# Validation report form for CDM project activities

## VALIDATION REPORT

<b>Title of the project activity</b>	Nam Pha Gnai hydropower project
<b>Version number of the validation report</b>	version 2.1
<b>Completion date of the validation report</b>	25/11/2015
<b>Version number of PDD to which this report applies</b>	Version 2.1
<b>Date when PDD was uploaded for global stakeholder consultation</b>	30/09/2014-29/10/2014
<b>Project participant(s)</b>	Nam Pha Gnai Hydropower Co., Ltd. Swiss Carbon Assets Limited
<b>Host Party</b>	Lao PDR
<b>Estimated annual average GHG emission reductions or net removals in the crediting period (tCO<sub>2</sub>e)</b>	62,184tCO <sub>2</sub> /a
<b>Sectoral scope(s) and selected methodology(ies)</b>	1 Energy industries (renewable-/non-renewable sources) ACM0002, version 16 consolidated baseline methodology for grid-connected electricity generation from renewable sources.
<b>Name of DOE</b>	TÜV Rheinland (China) Ltd.
<b>Name, position and signature of the approver of the validation report</b>	Mr. Henri Phan DOE Manager

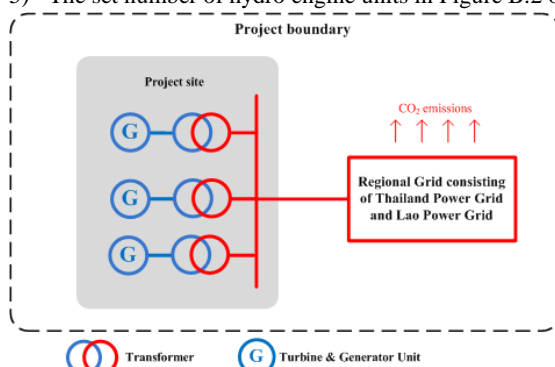
CL ID	01	Section no.	D7	Date:	12/01/2015
Description of CL					
<p>Refer to PDD description,</p> <p>1) For the Physical/Geographical location of the project activity, please clarify whether the coordinates (i.e. 18 59'45"N, 102 51'18"E) mentioned in the section A.2.4 of the PDD is for the project's dam or for the project's power house or for other infrastructure of the project. And relevant evidence shall be provided for check;</p> <p>2) Figure A.1 in the PDD was not sufficiently clear to show the project physical location, and at least the project located river shall be visible as an object of reference in the map;</p> <p>3) The project located river addressed in section A.1 of PDD is inconsistent with indicated in FSR; 4) According to PDD form instruction, a list of the facilities, systems and equipment that will be installed are requested to be included in section A.3 of PDD;</p> <p>5) Please confirm the set number of hydro engine units in Figure B.2 of PDD, which is inconsistent with described in section A.1 of PDD.</p>

- 1) According to the PPA, the coordinates for the weir are 19.009331 N, 102.872314 E. The PPA was provided to DOE to crosscheck.
- 2) The map was update to clear show the project location.
- 3) The description of the project location was corrected according to the FSR.
- 4) The description of the project facilities were added in the A.3 of PDD. The parameters for the main equipment as follows:

- 5) The set number of hydro engine units in Figure B.2 of PDD was corrected.
